## **City of Sweet Home**

**Request for Proposals**  
for  
**SWEET HOME WATER TREATMENT PLANT  
FINISHED WATER AND BACKWASH  
PUMPING SYSTEMS IMPROVEMENT**  
Addendum No. 1

**ADDENDUM NO. 1  
TO  
Request for Proposals  
FOR  
SWEET HOME WATER TREATMENT PLANT FINISHED WATER AND BACKWASH PUMPING  
SYSTEMS IMPROVEMENT  
December 8, 2021**

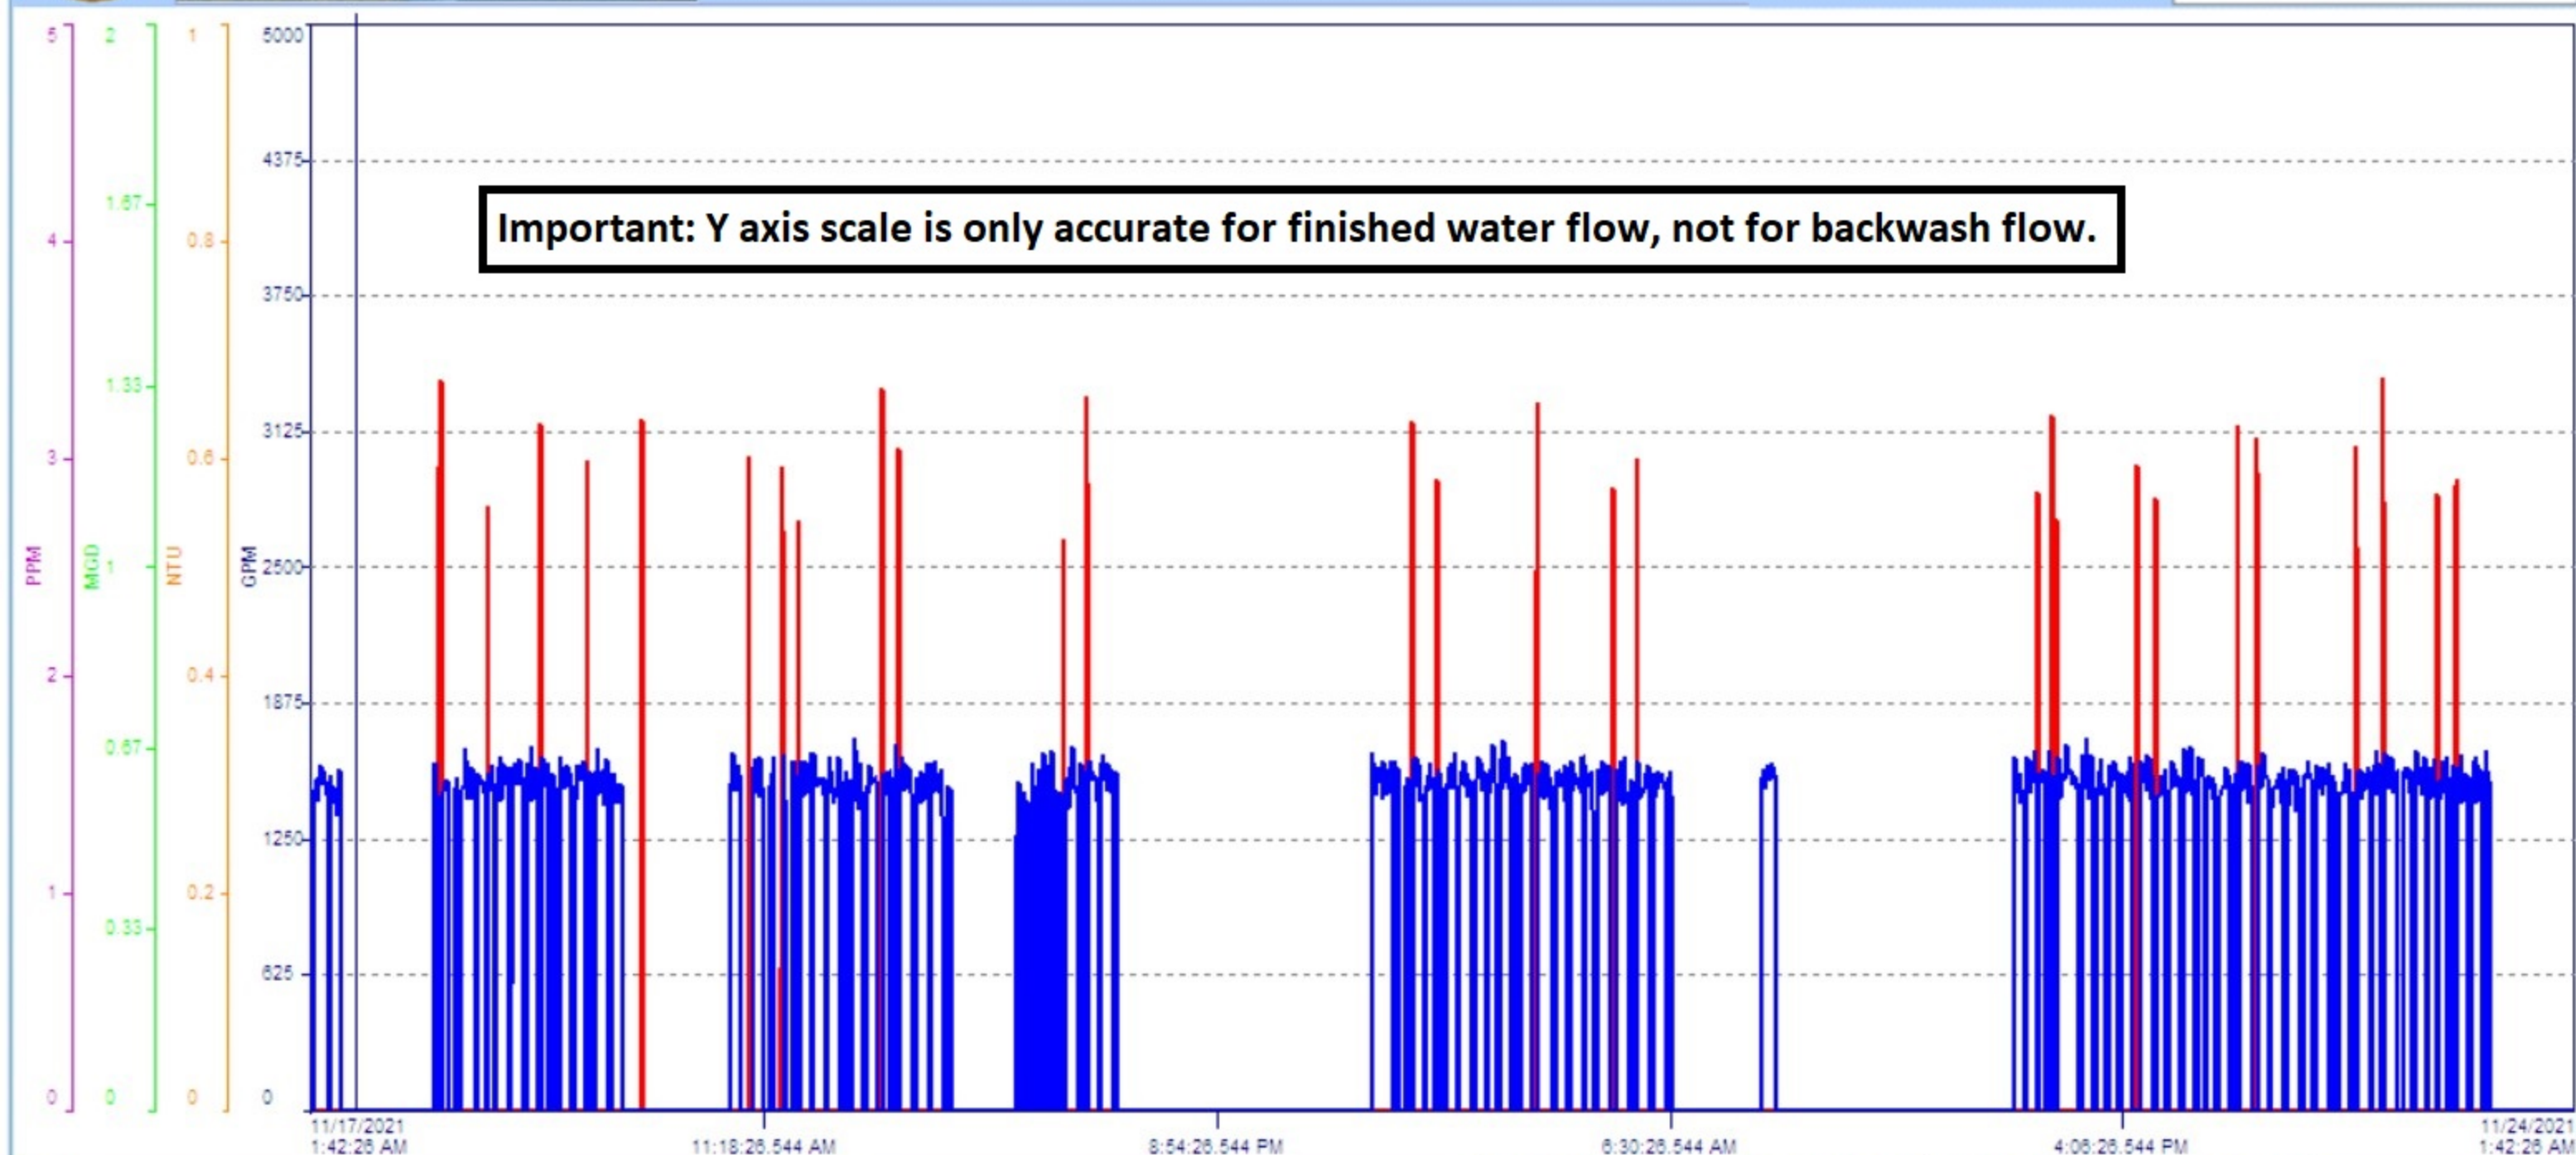
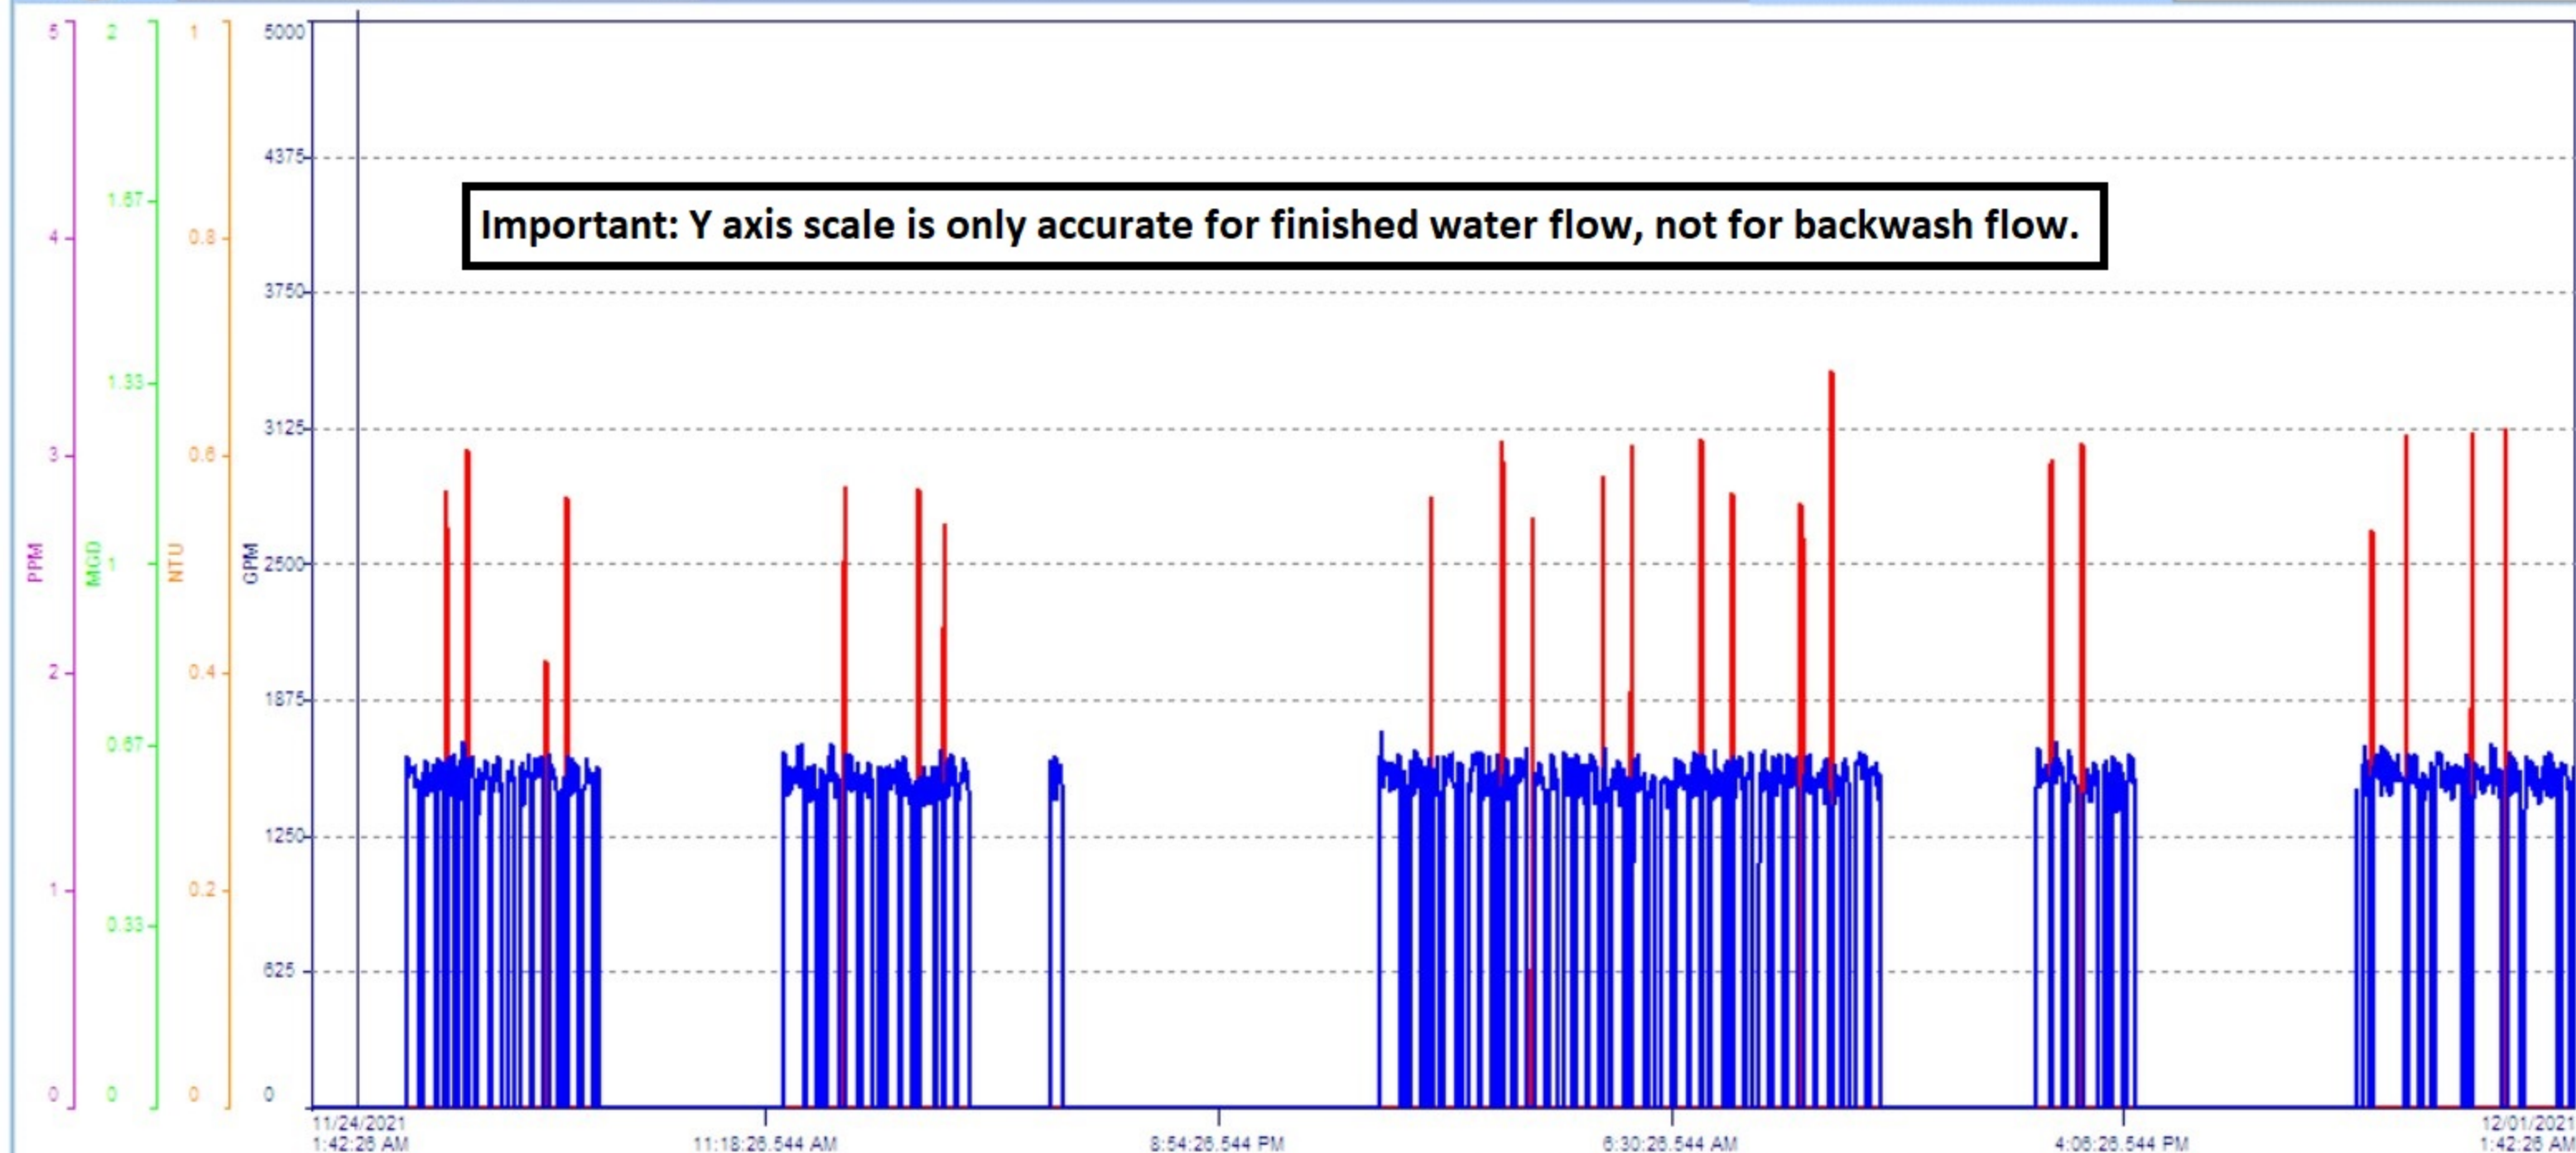
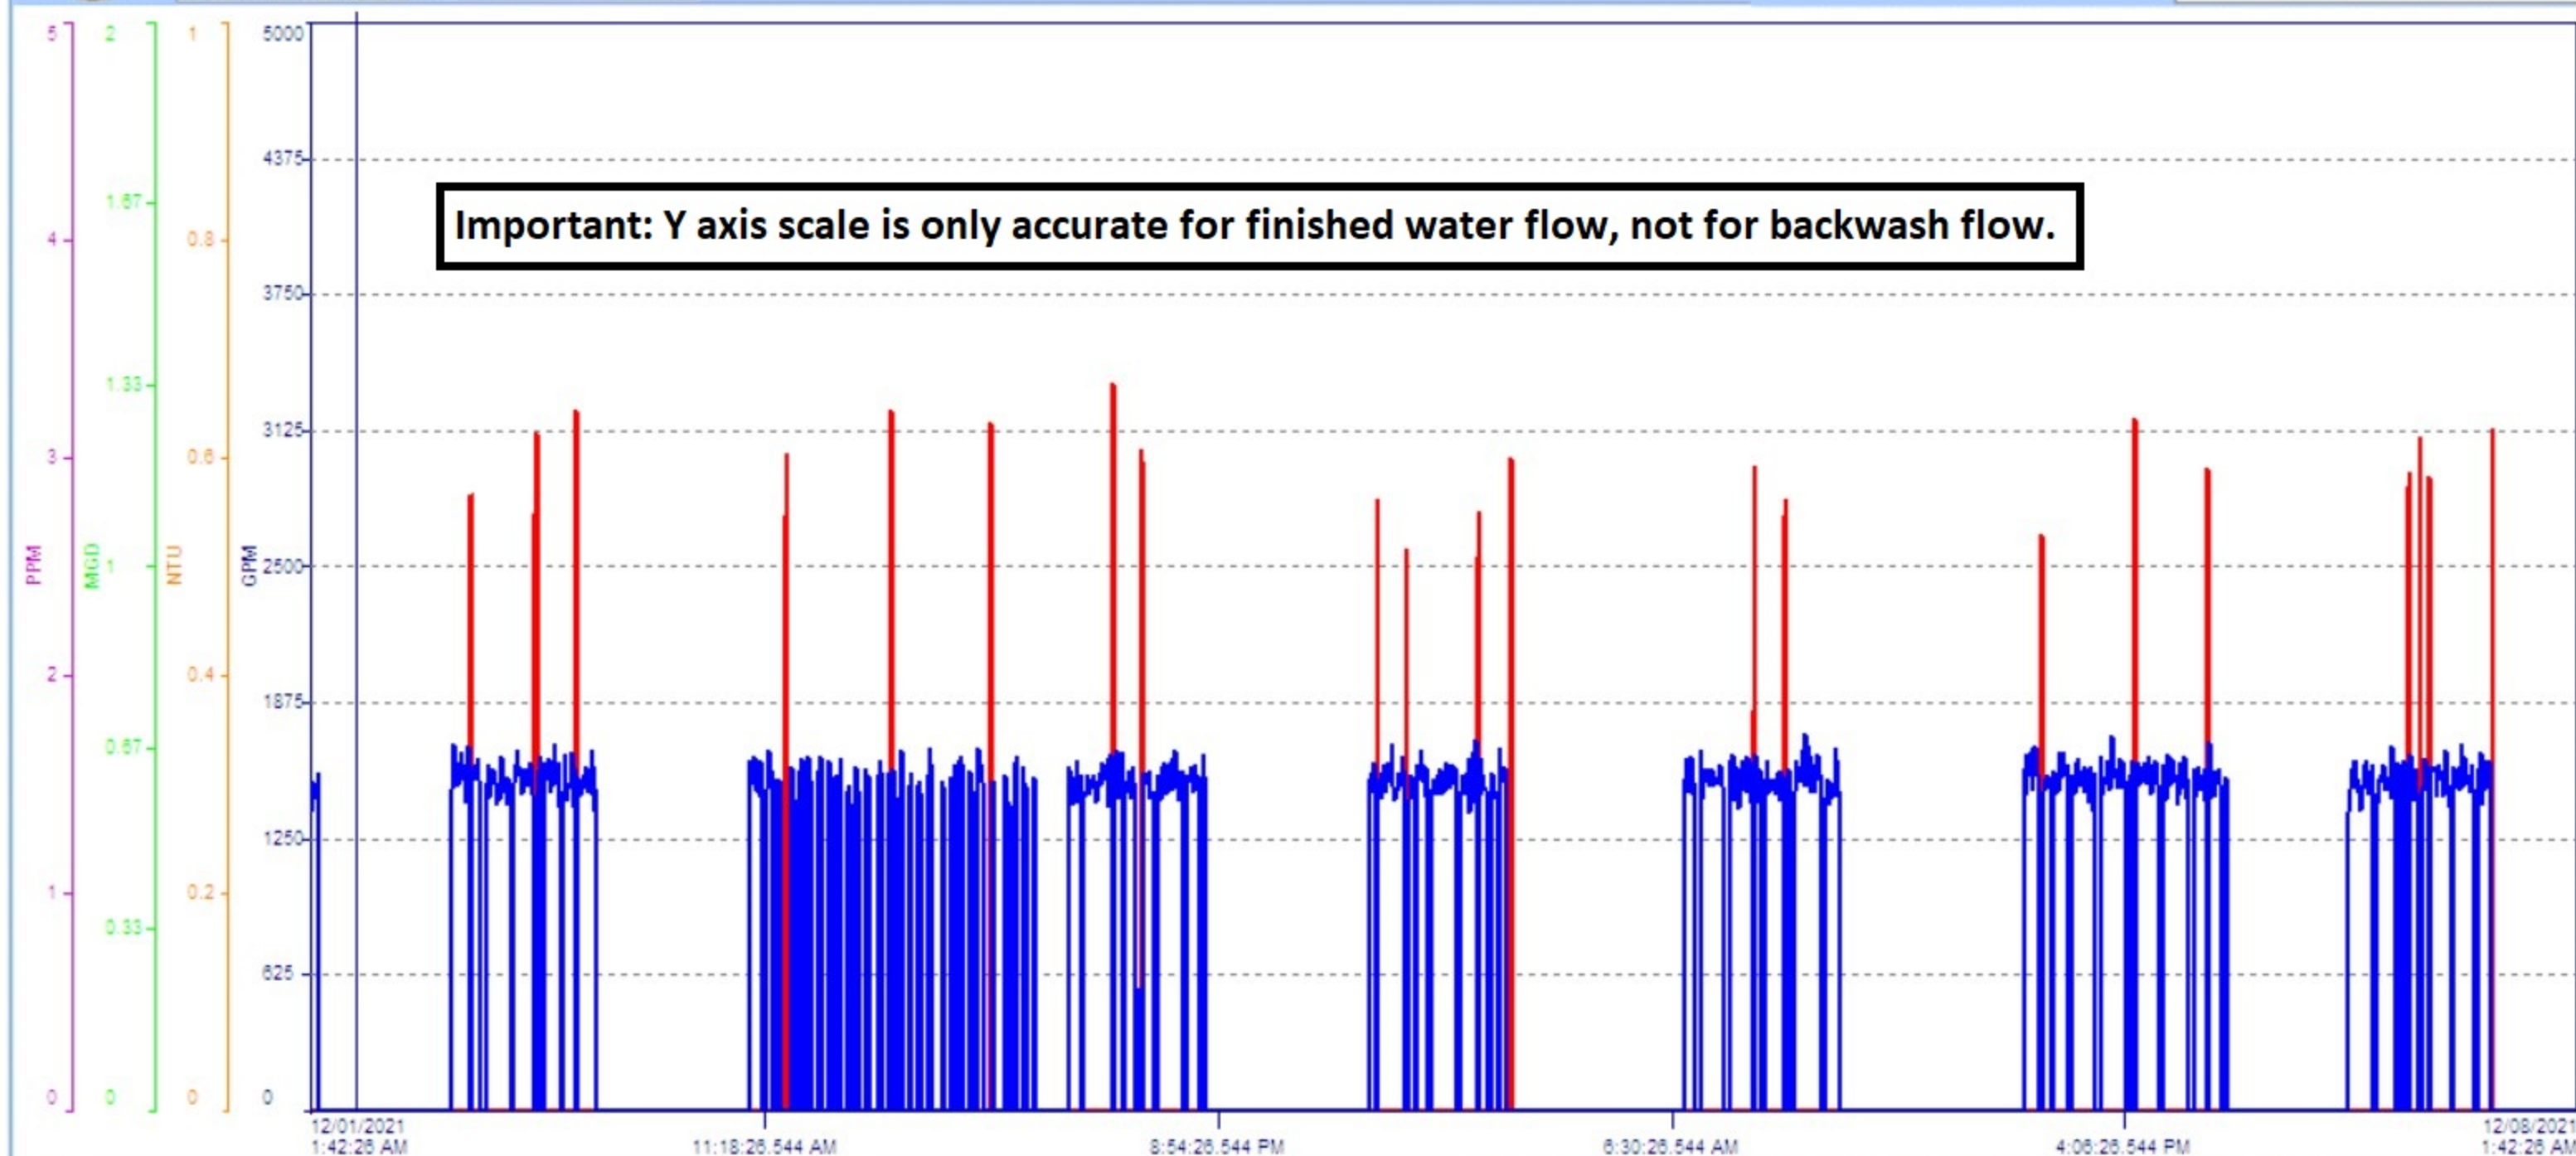
**4. *How often do they backwash?***

**Response:** Each filter is backwashed approximately two (2) times per day. Recent trendlines are attached for reference.
